MAIN LEVEL FLOOR PLAN W/ MEZZANINE 'A'

ARCO Concrete Contractors
New Maintenance Building
 7470 SOUTHMOOR DRIVE
 FOUNTAIN, COLORADO 80817

PRELIMINARY REVIEW ONLY
NOT FOR CONSTRUCTION

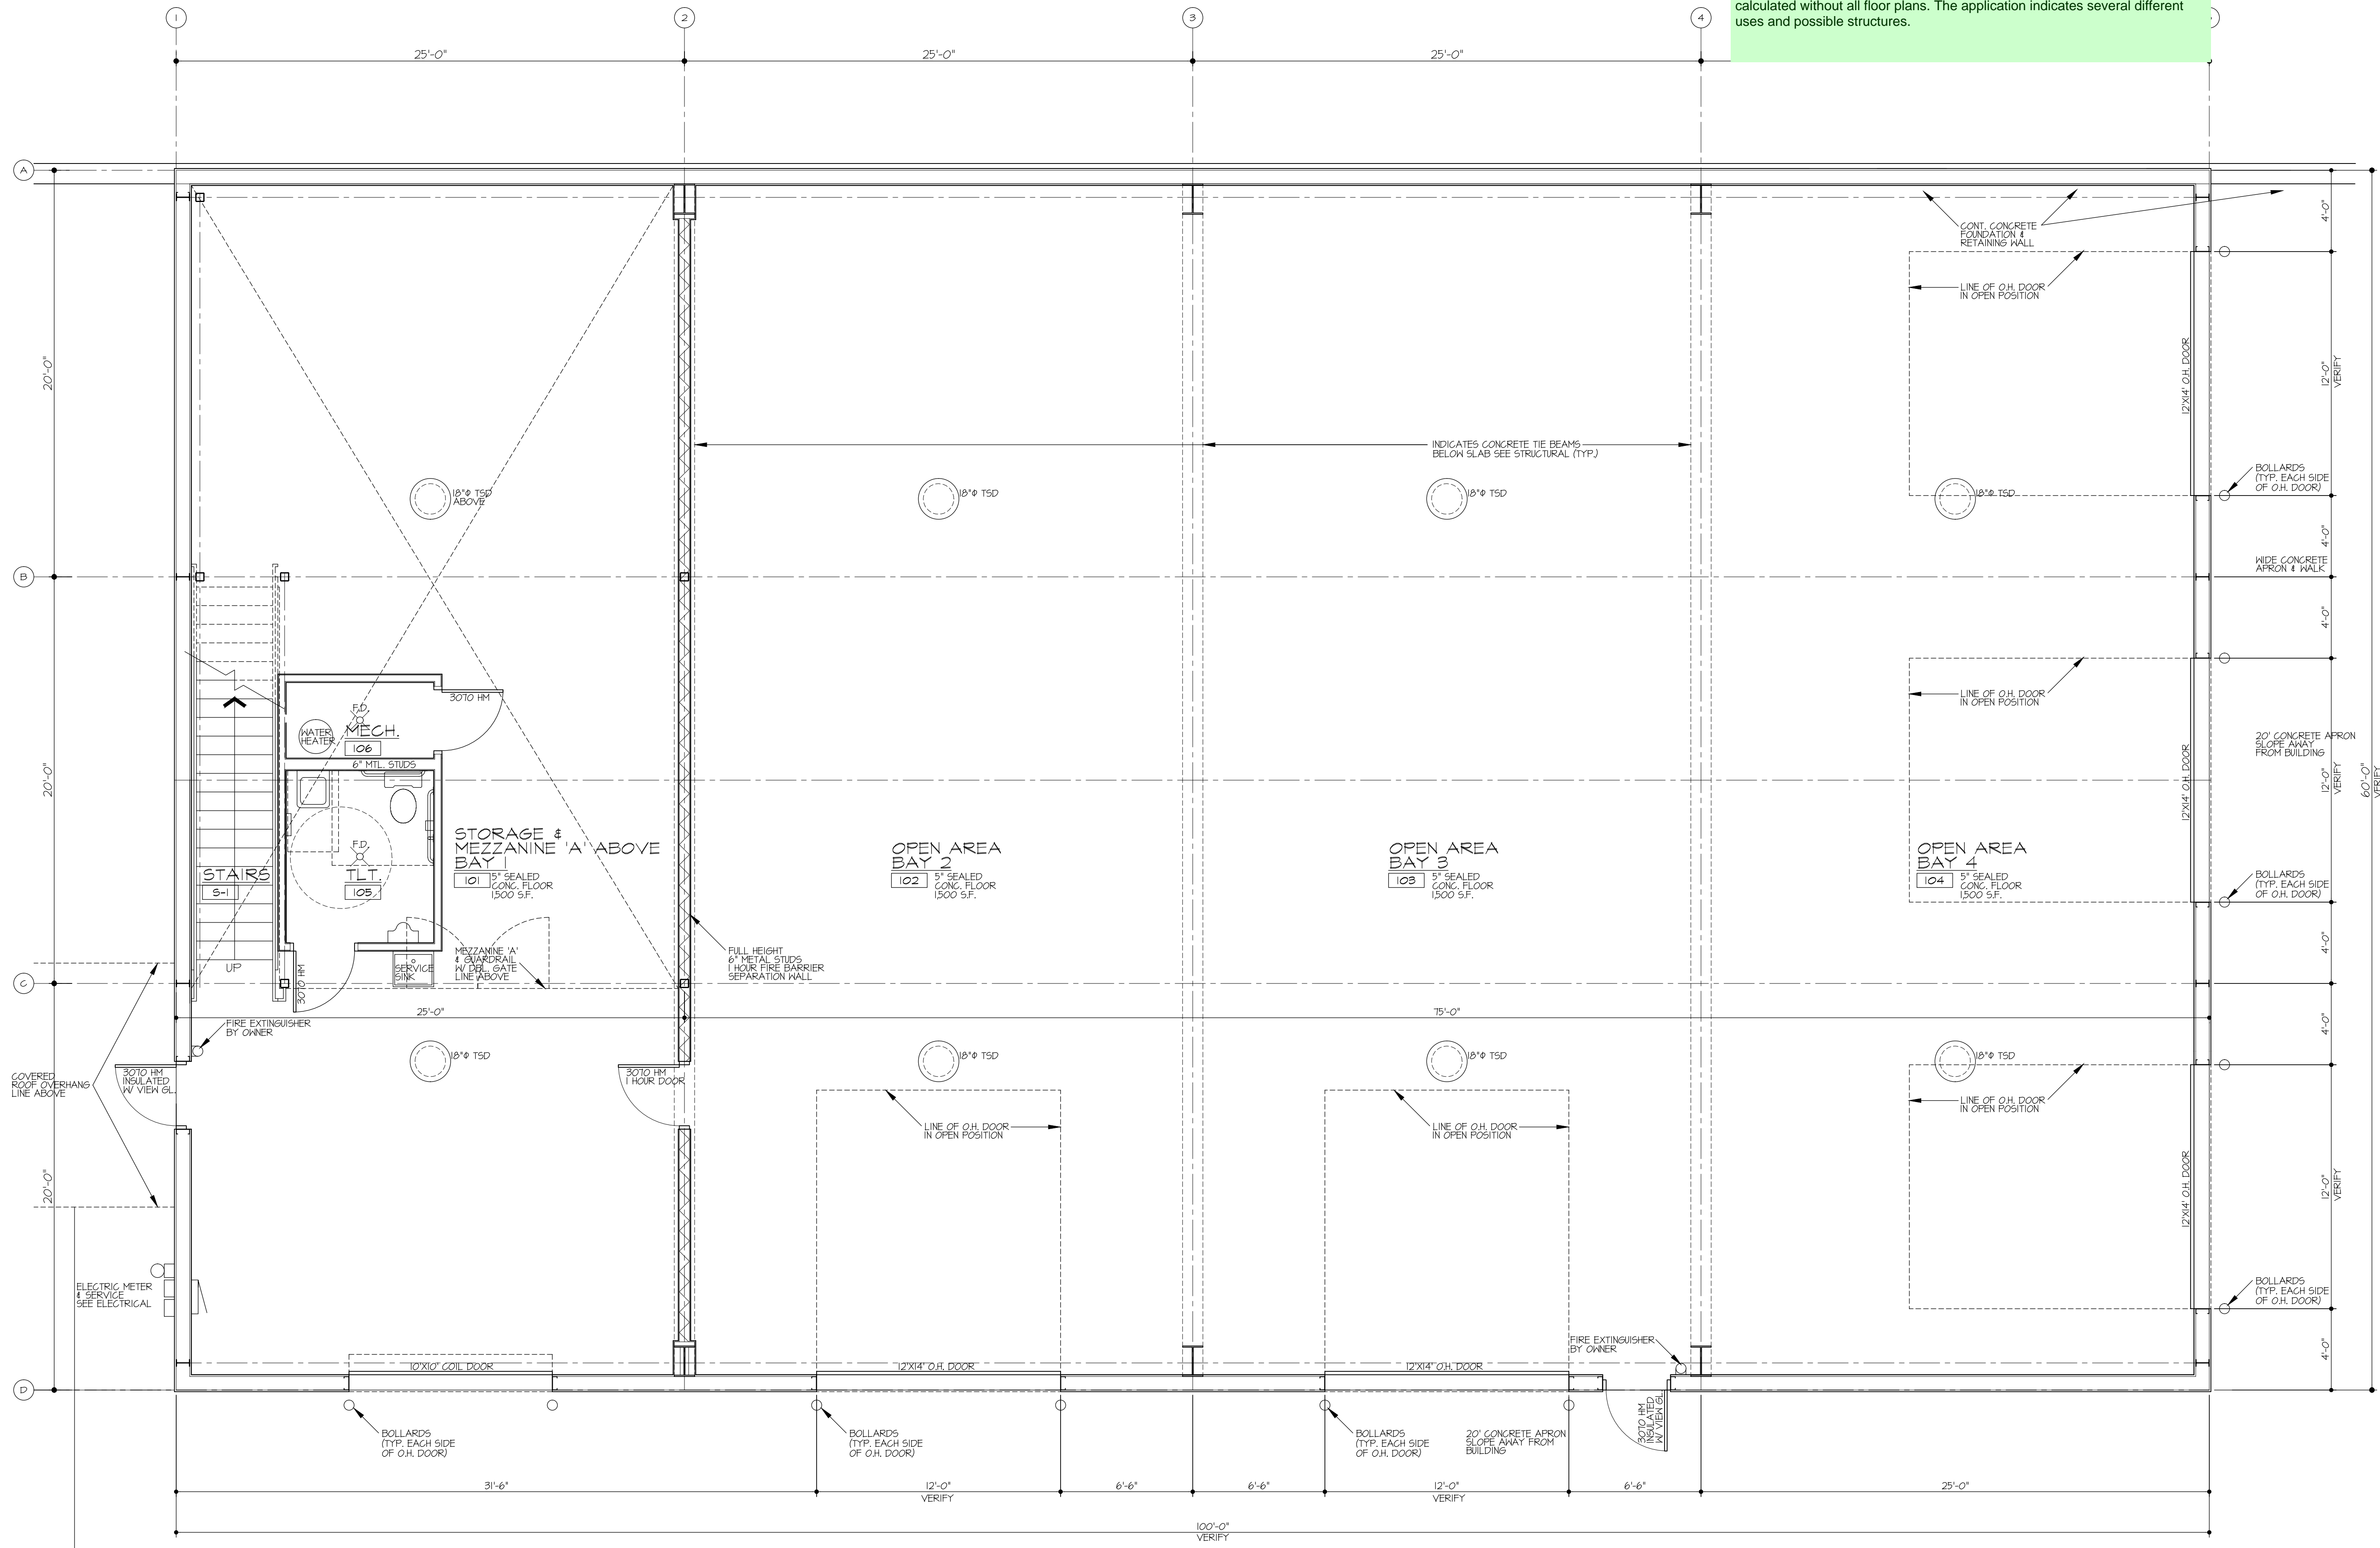
Please include all existing and proposed structures. Parking cannot be calculated without all floor plans. The application indicates several different uses and possible structures.
